Access Compliance Report

Public Rights-of-Way

(Curb Ramps)

Intersection ID: 8364	Main Street: ENGLISH_DR	Cross Street: LASALLE_ST	Location: NW
ADA ID: F476117A992C	Ramp Type: Perp	Initial Pass/Fail: Fail	Overall Compliance: No
Severity Score: 13.75			
Codes/Mitigation Info/Possible Solution		Field Measurements/Component Compliance

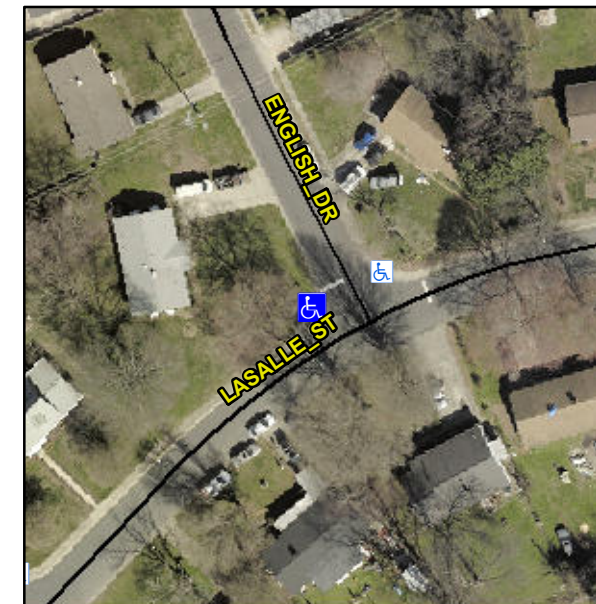
R304.2.2, R304.5.3

Compliance	Description	Data	Compliance	Description	Data
N/A	Ramp Length (in)	27.0	No	Ramp Slope (%)	9.8
Yes	Ramp Width (in)	48.0	No	Ramp XSlope (%)	3.5
N/A	Flare Type LT	N/A	N/A	Flare Type RT	N/A
N/A	Flare Slope LT (%)	N/A	N/A	Flare Slope RT (%)	N/A
N/A	Flare Traversable LT?	N/A	N/A	Flare Traversable RT?	N/A
N/A	Landing Length (in)	N/A	N/A	DWS Provided?	N/A
N/A	Landing Width (in)	N/A	N/A	DWS Contrast?	N/A
N/A	Landing Slope (%)	N/A	N/A	DWS Length (in)	N/A
N/A	Landing X Slope (%)	N/A	N/A	DWS Full Width?	N/A
N/A	Landing Curb? (Y/N)	N/A	N/A	DWS Offset (in)	N/A
N/A	Shared Landing?	N/A			
N/A	Gutter Ponding?	N/A	N/A	Gutter Slope (%)	N/A
N/A	Gutter Lip Ht (in)	N/A	N/A	Gutter X Slope (%)	N/A
N/A	Painted X Walk1?	No	N/A	Painted X Walk2?	N/A
	X Walk 1 Direction	To NE		X Walk 2 Direction	N/A
N/A	X Walk 1 Width (in)	N/A	N/A	X Walk 2 Width (in)	N/A
	X Walk 1 Slope (%)	6.5		X Walk 2 Slope (%)	N/A
	X Walk 1 X Slope (%)	0.7		X Walk 2 X Slope (%)	N/A

Remove & Replace Entire Ramp.
